SLG47004-A Errata Note

This document contains the known errata for SLG47004-A and the recommended workarounds.

Figure 1. Inrush Current at V_{DDA} Slew Rate = $1 \text{ V}/\mu\text{s}$

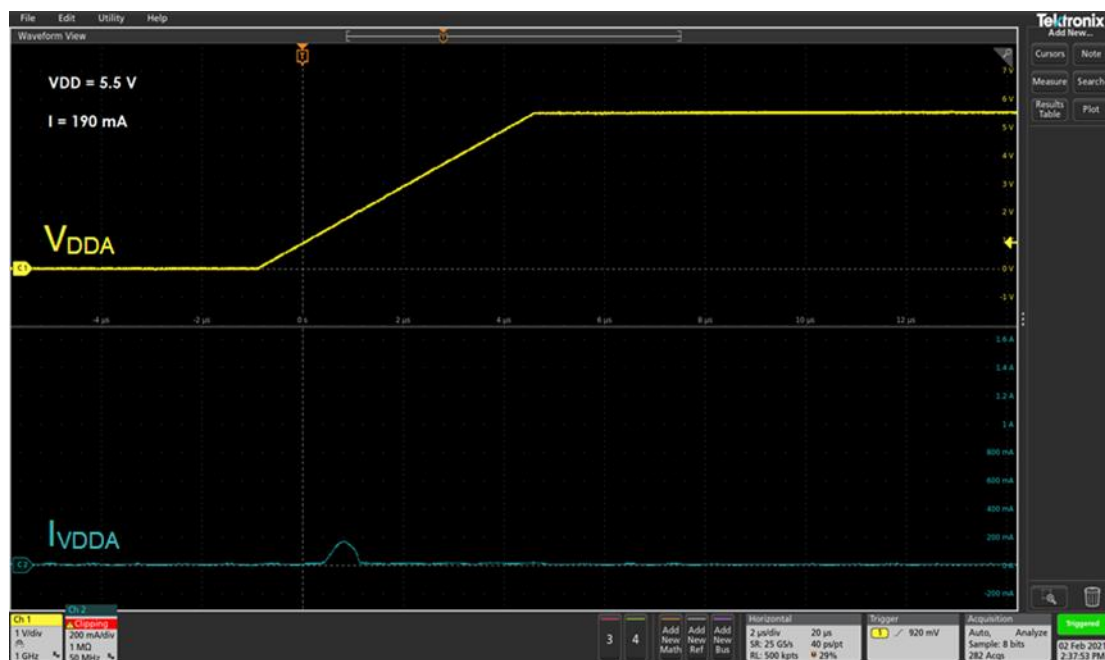
When powering ON the Analog V_{DD} with a slew rate exceeding $1 \text{ V}/\mu\text{s}$, a large inrush current exceeding 190 mA flows through the analog circuitry's ESD power clamp structure. With faster slew rates ($2 \text{ V}/\mu\text{s}$), the inrush current through V_{DDA} can reach 890 mA .

For larger slew rates and higher temperatures, this behavior can permanently damage the SLG47004-A by creating a low impedance path between the power supply rails. This damage is caused by bipolar snapback within the ESD protection device. For this reason, Renesas has introduced an Abs. Max. parameter in the SLG47004-A's base die datasheet specifying a maximum slew rate of $2 \text{ V}/\mu\text{s}$ on V_{DDA} .

To avoid this behavior, we recommend limiting the Analog V_{DD} 's slew rate to a value lower than 2 V/ μ s, as this will protect the SLG47004-A while limiting inrush current. This can be done by many methods including the use of slew rate limited analog switches or DC/DC converters. Alternatively, you could increase the capacitance on the SLG47004-A's Analog VDD line and place a series resistance on the output of the power supply. Note that this resistor will introduce additional power loss to the system and will cause voltage noise on the analog power rail.
